TELEDYNE CONTINENTAL[®] AIRCRAFT ENGINE
CRITICAL SERVICE BULLETIN
COMPLIANCE NECESSARY TO MAINTAIN SAFETY

Category 2
CSB07-2

SUBJECT: TURBOCHARGER WASTEGATE OIL INLET FITTING
INSPECTION and REPLACEMENT

FIGURE 1
INSPECTION AREA

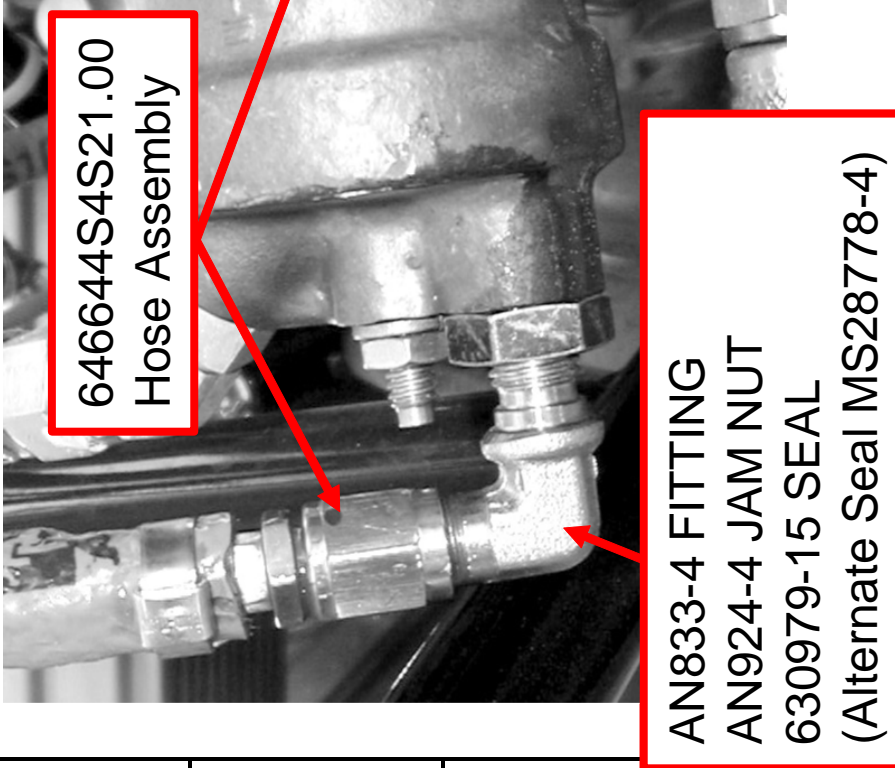
1. Using the airframe manufacturer's maintenance instructions, open or disconnect each engine cowl flap to allow access to the wastegate actuator. (Reference Figure 1)
2. Inspect the oil inlet fitting of the wastegate actuator.
3. If the fitting is a one-piece 90° fitting as shown in Figure 2A, no further action is required. Reassemble the previously removed airframe components using the applicable airframe manufacturer's maintenance instructions. Make engine log book entries for each engine inspected certifying compliance with this Critical Service Bulletin.
4. If the fitting is a two piece assembly (straight fitting and 90° fitting) as shown in Figure 2B, proceed to the fitting replacement instructions contained in this Critical Service Bulletin.

1. Using the airframe manufacturer's maintenance instructions, open or disconnect the engine cowl flaps and remove the engine cowling as necessary to allow access to the wastegate actuator. (Reference Figure 1)

FIGURE 3
FITTING REPLACEMENT DETAIL

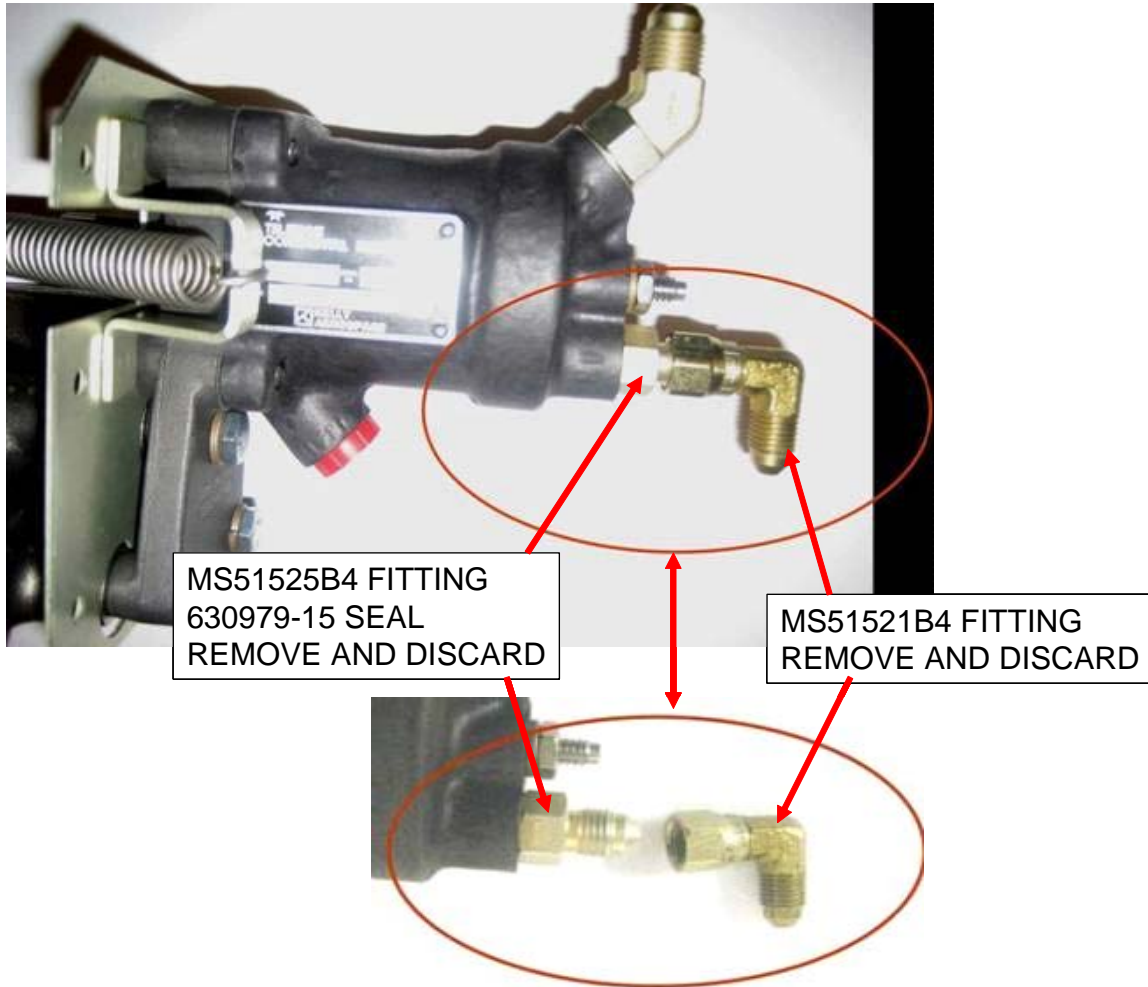
3. Remove the 90 degree fitting P/N MS51521B4, straight fitting MS51525B4, and O-ring seal P/N 630979-15 from the oil inlet on the wastegate and discard. (Reference Figure 3)

6. Install replacement 90 degree fitting P/N AN833-4 with new O-ring P/N 630979-15 (O-Ring P/N MS28778-4 is an approved alternate) and Jam nut P/N AN924-4. Lightly lubricate the O-ring with clean 50W engine oil before installation.

7. Clock the P/N AN833-4 fitting to allow connection of wastegate oil pressure hose while maintaining sufficient clearance between the fitting and the airframe engine mount structure. While holding the fitting in position to ensure clearance between the fitting and the airframe engine mount structure, ensure that the o-ring is seated in the relief boss on the fitting. Screw

the jam nut finger tight against the fitting boss. Torque the jam nut to 85-105 inch-pounds while holding the correct fitting orientation.
